HumeLink

Amendment Report

- Amended project footprint
- Construction compound site
- Bannaby substation compound (C12) as shown in EIS
- Existing Transgrid transmission line
- Waterway

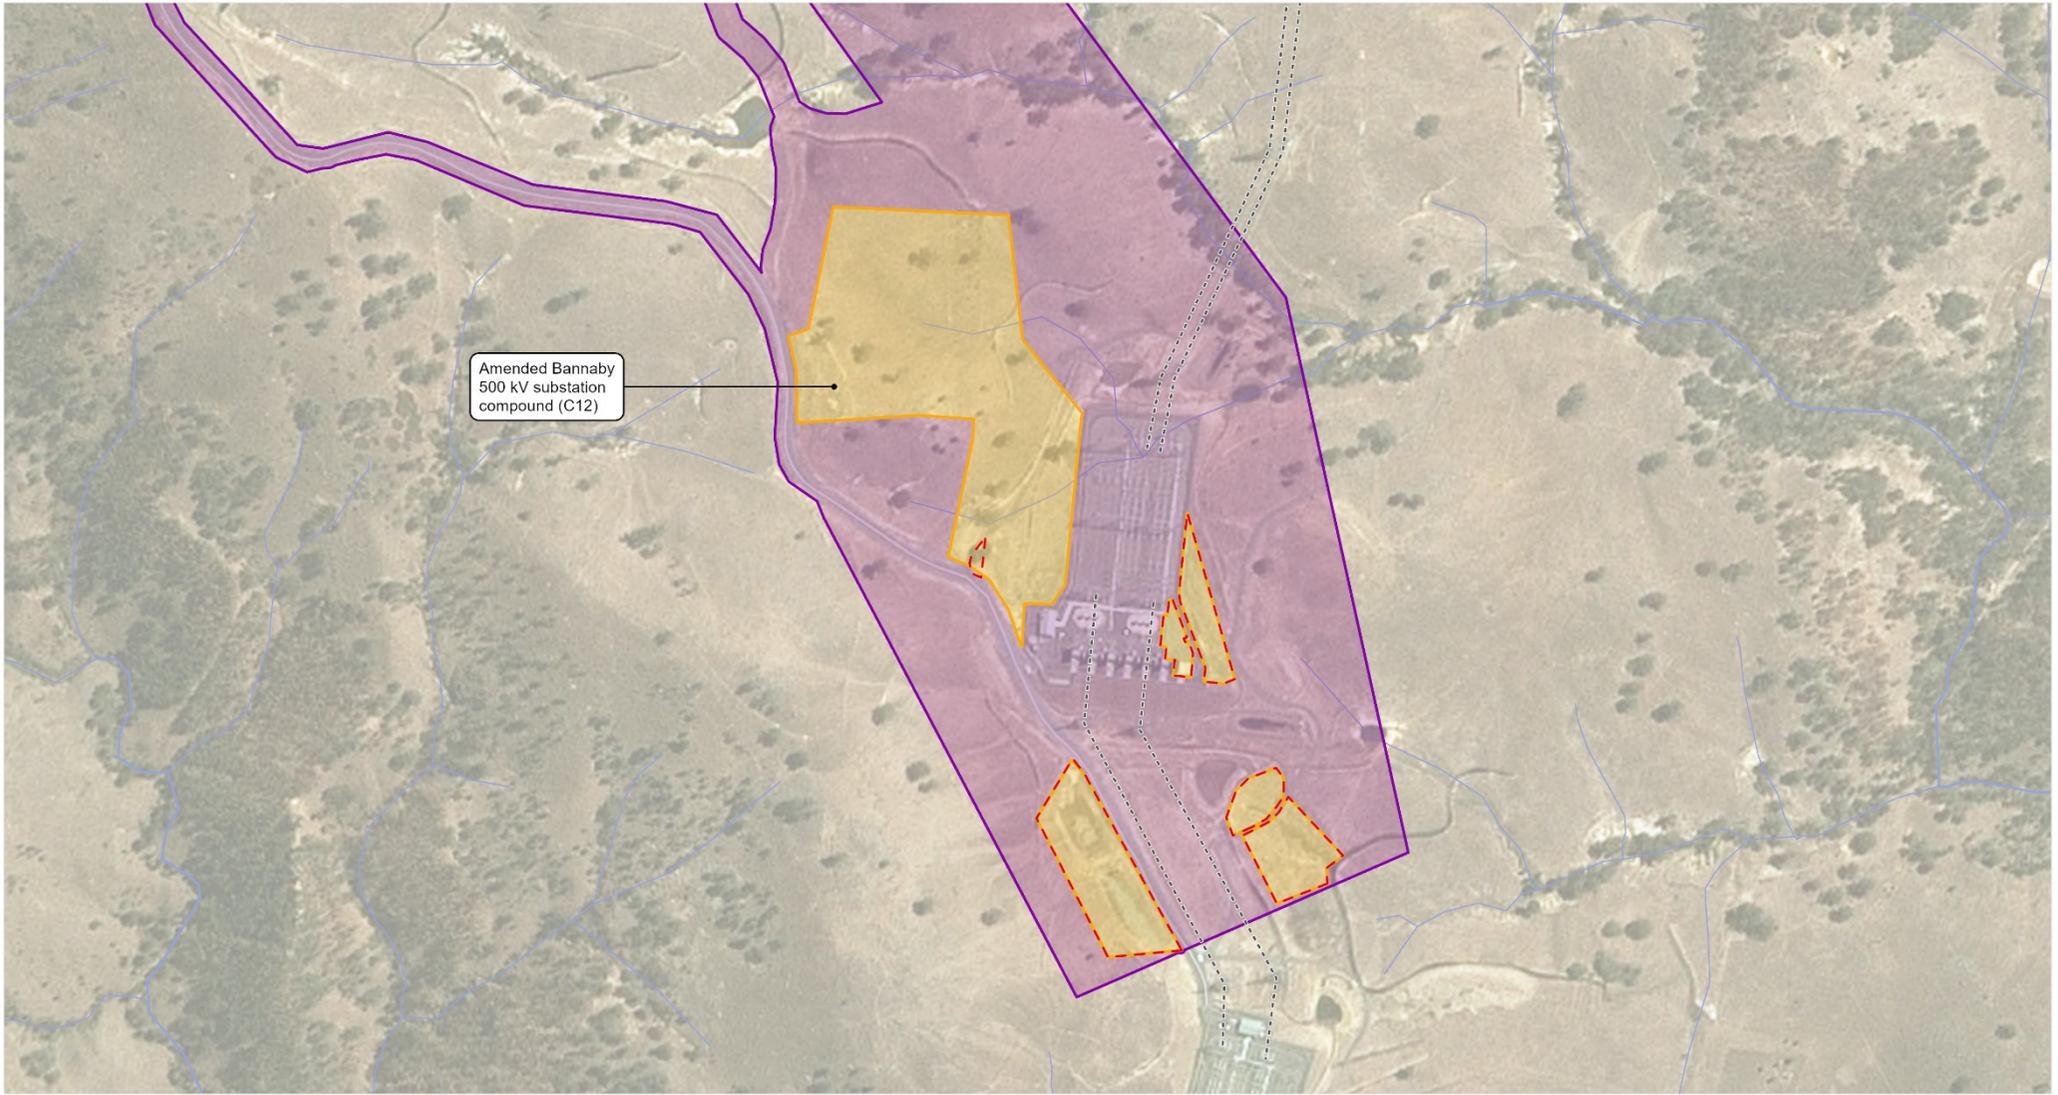
Table 3-4 provides a consolidated list and description of the standalone construction compounds. Further detail is provided in Appendix A (Updated project description). Figure 3-4 shows the locations of the changed standalone construction compounds.

FIGURE 3-6: Additional telecommunications connections to existing substations

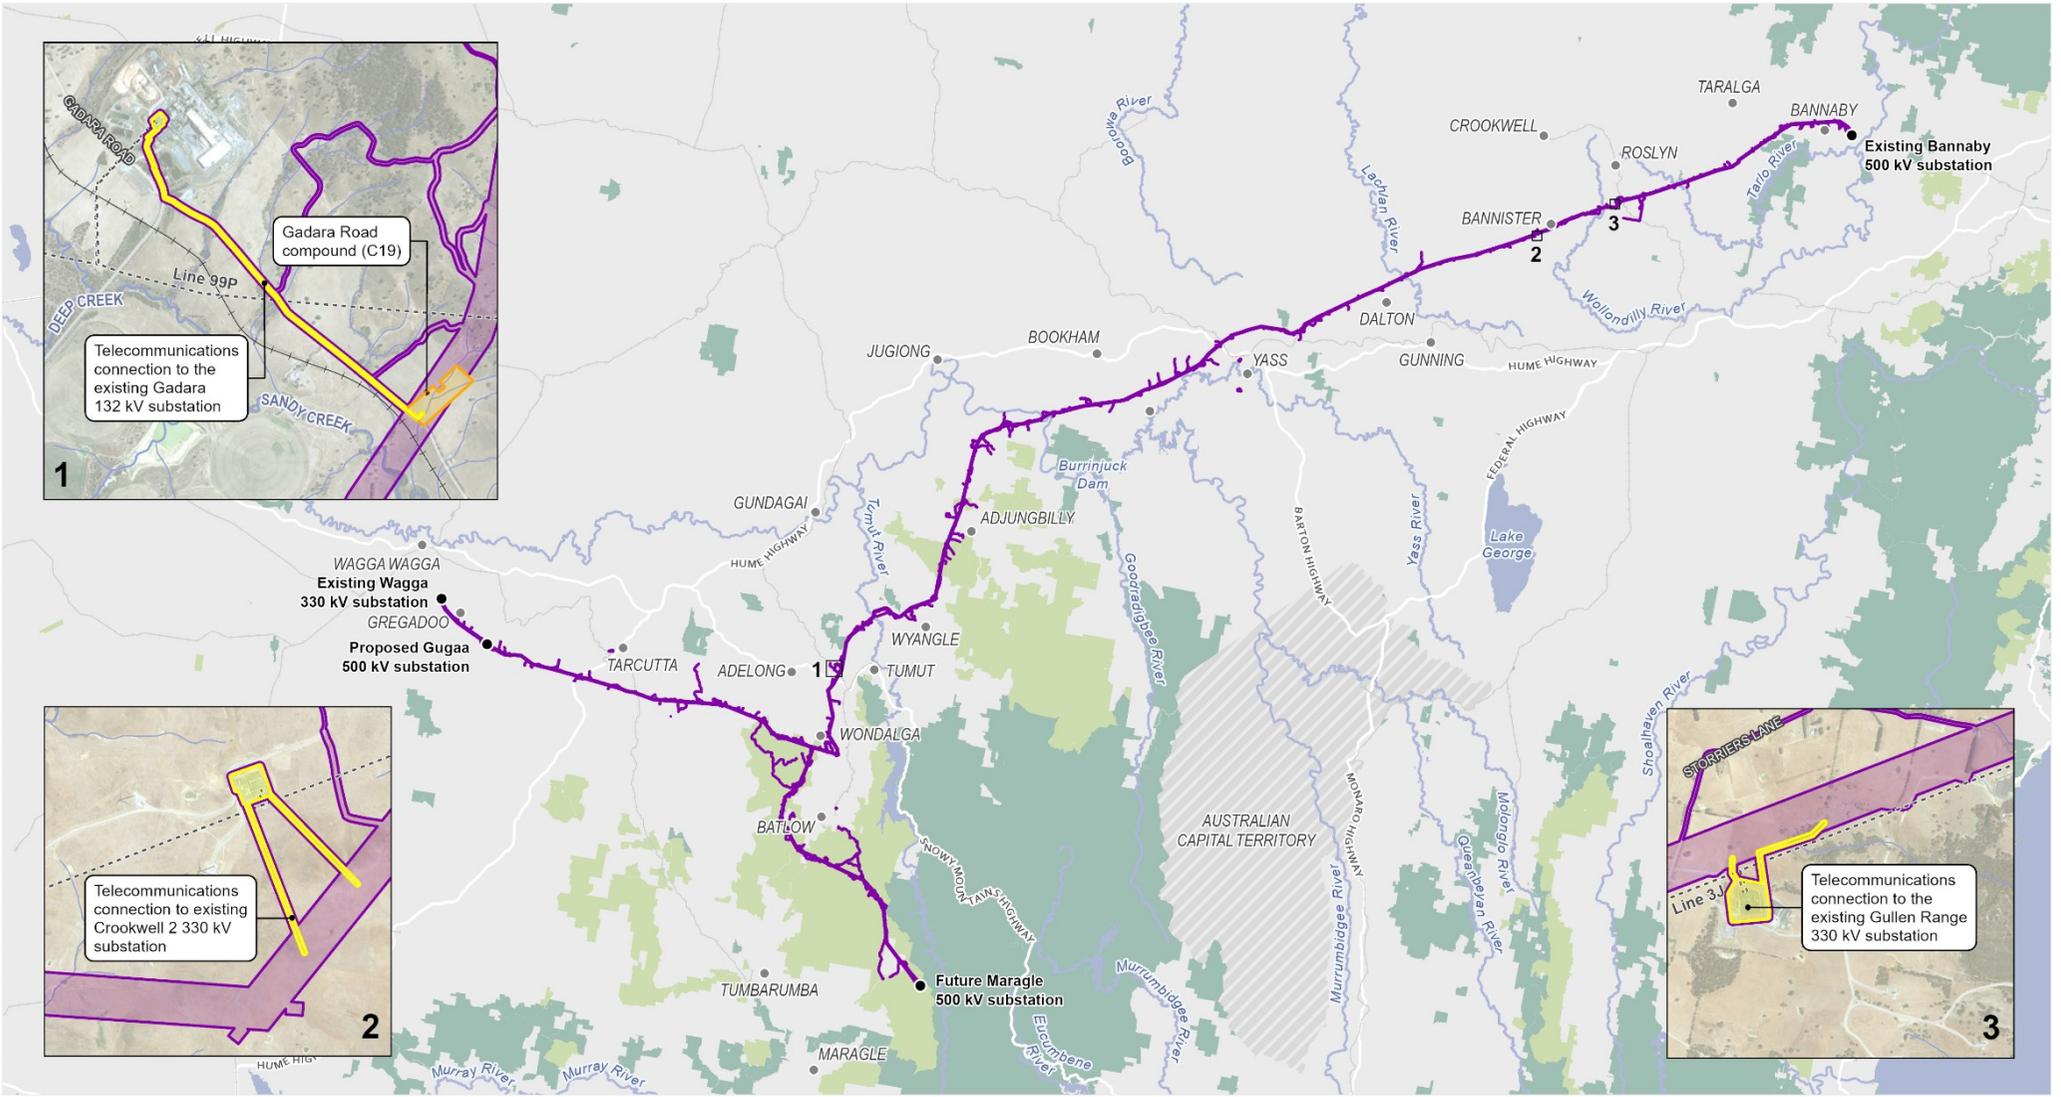
Figure 3-6 shows the locations of additional telecommunications connections to the substations along the transmission line corridor.
